# RENESAS TECHNICAL UPDATE

Product Category	MPU/MCU		Document No.	TN-RX*-A0279A/E	Rev.	1.00
Title	Errata Regarding Setting of the RCR4.RCKSEL Bit for the RX66N Group, RX72M Group, and RX72N Group MCUs		Information Category	Technical Notification		
Applicable Product	RX66N Group, RX72M Group, RX72N Group	Lot No.	Reference Document	User's Manual: Hardware for applicable products listed under Related Documents on the last page		
		All

Figure 33.14 Initialization Procedure (When Using Main Clock)

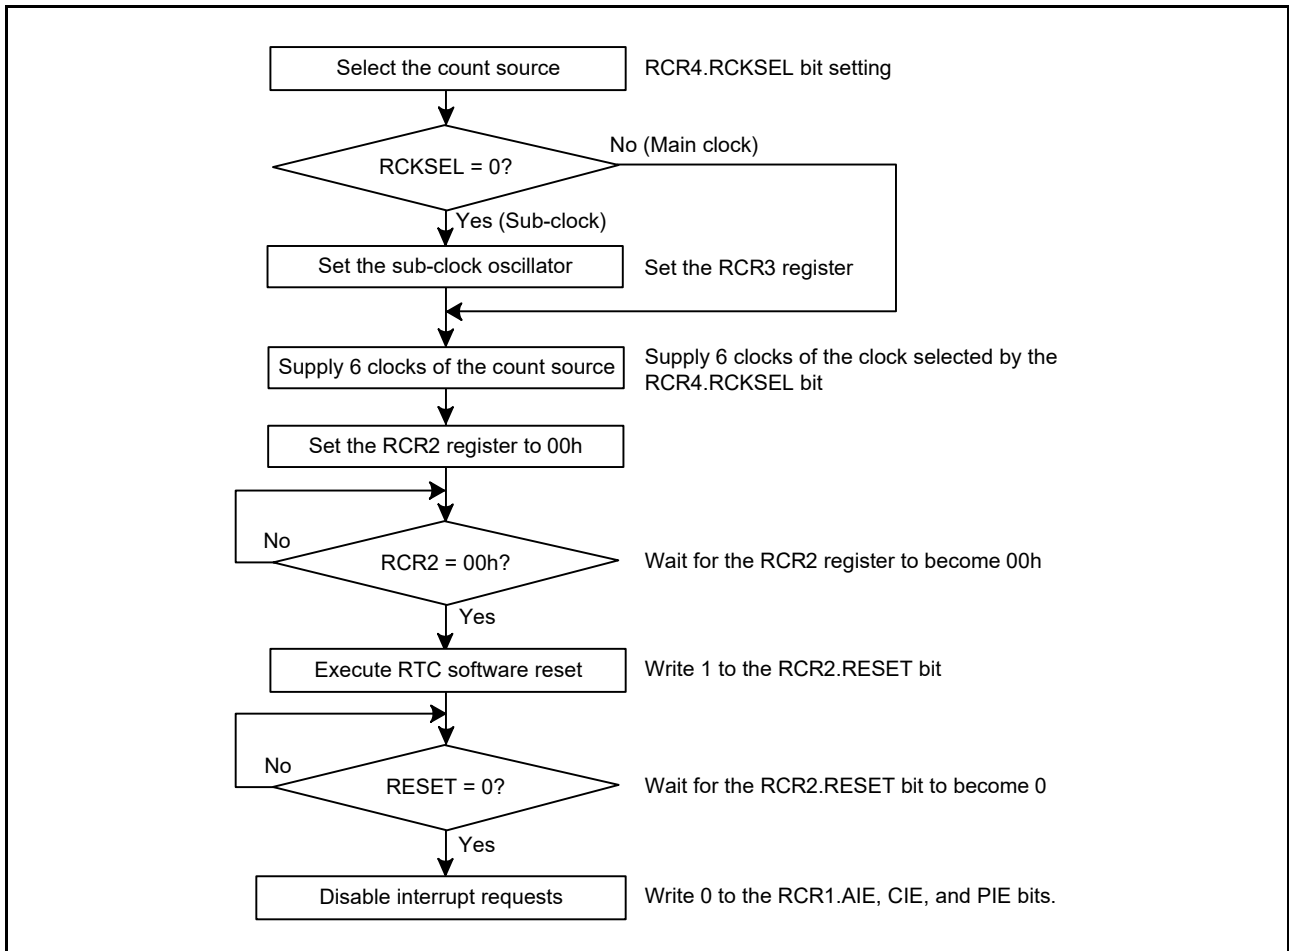
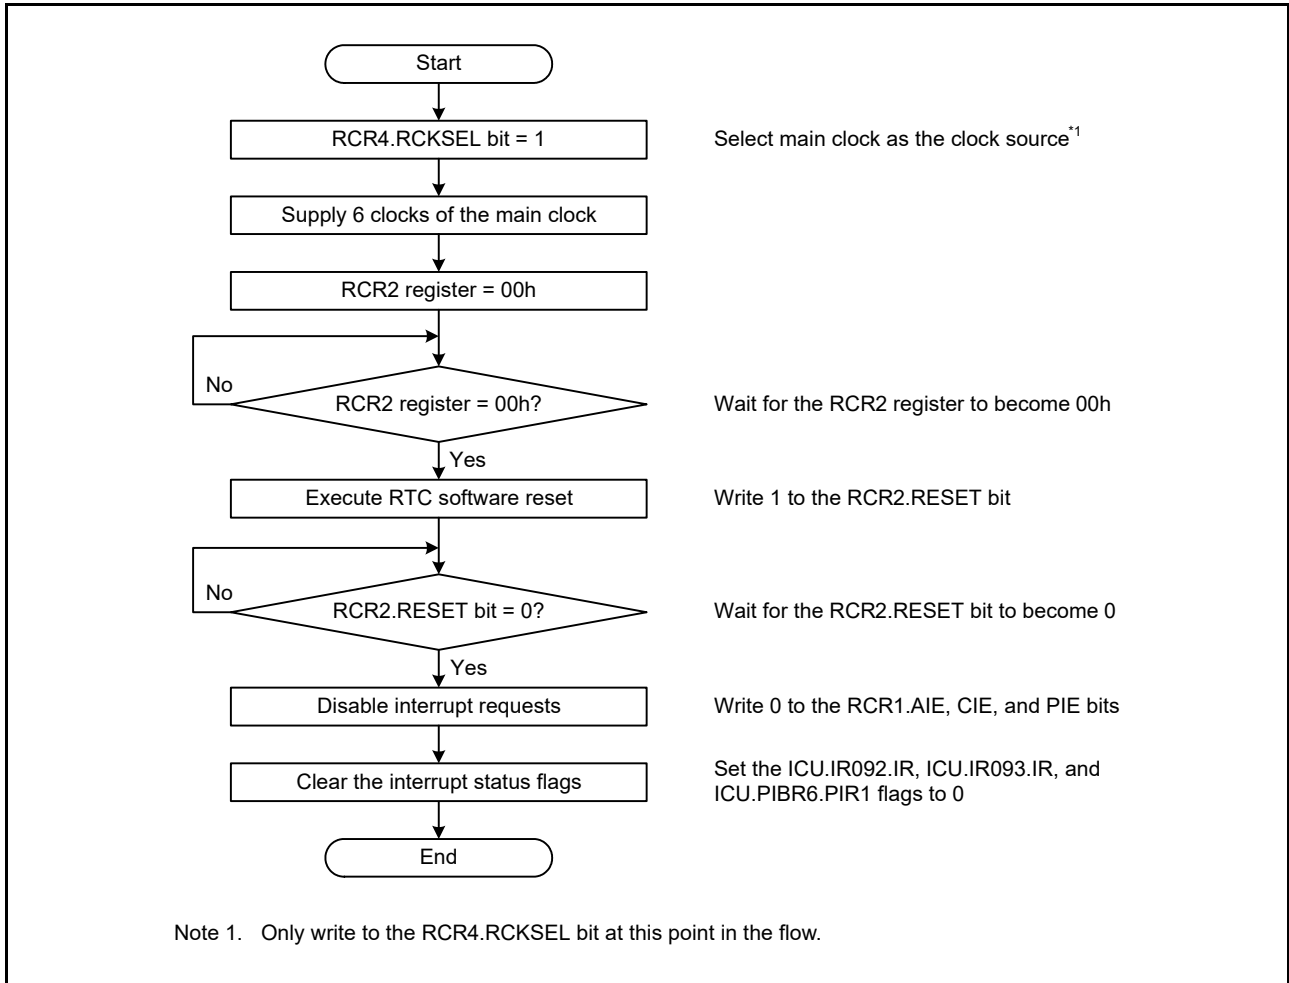
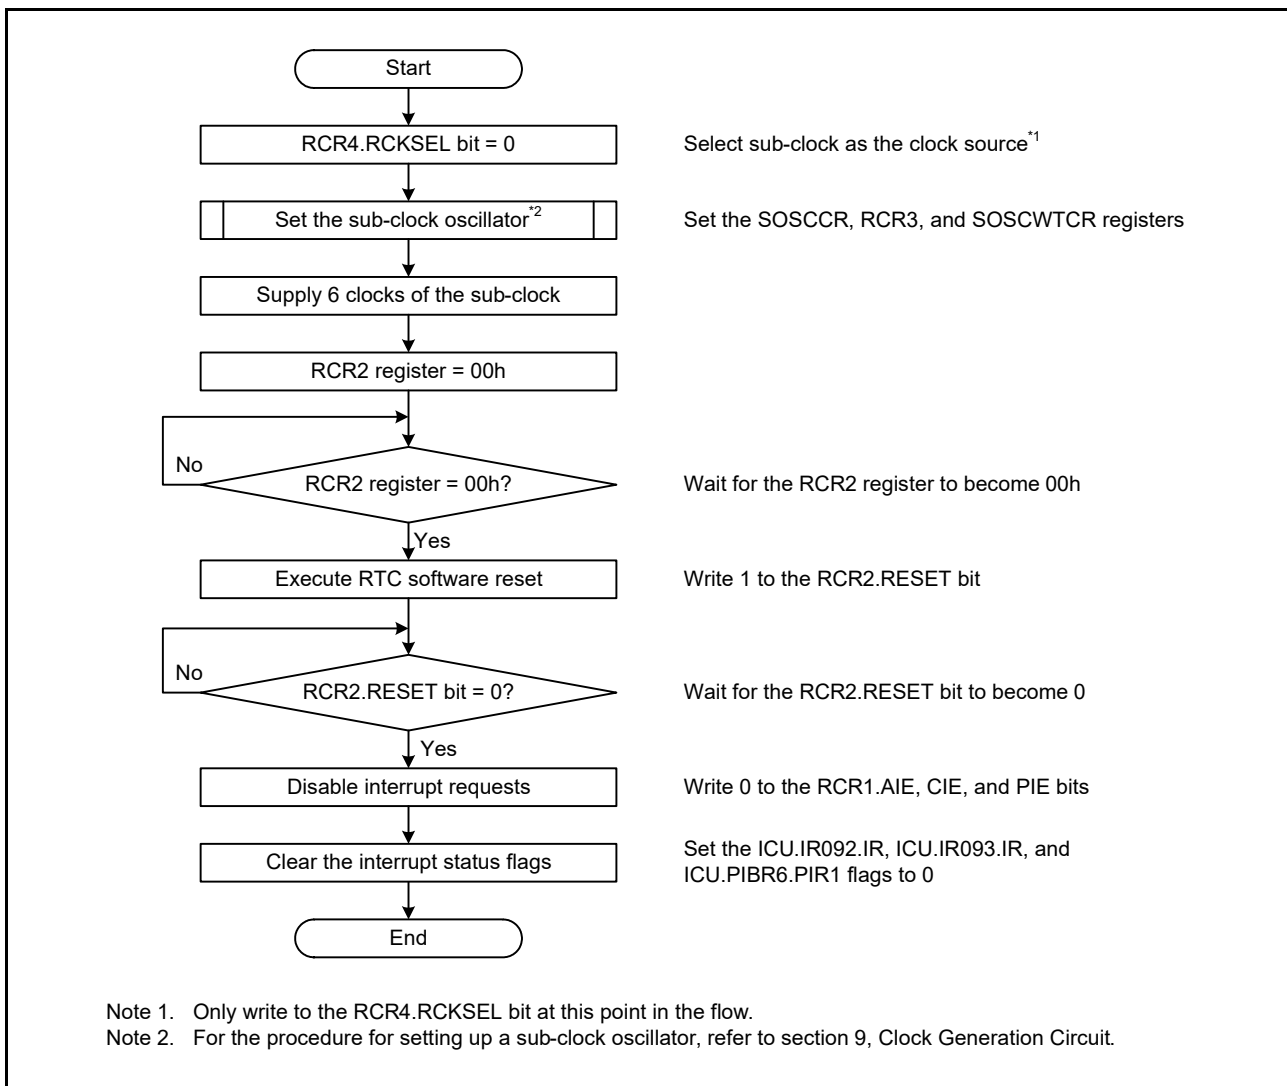
Figure 33.14, Initialization Procedure, in section 33.6.7, Initialization Procedure When the Realtime Clock is Not to be Used, is separated into two flowcharts as follows to suit the clock that is in use. A step of clearing the interrupt status flags is also added to both flowcharts.
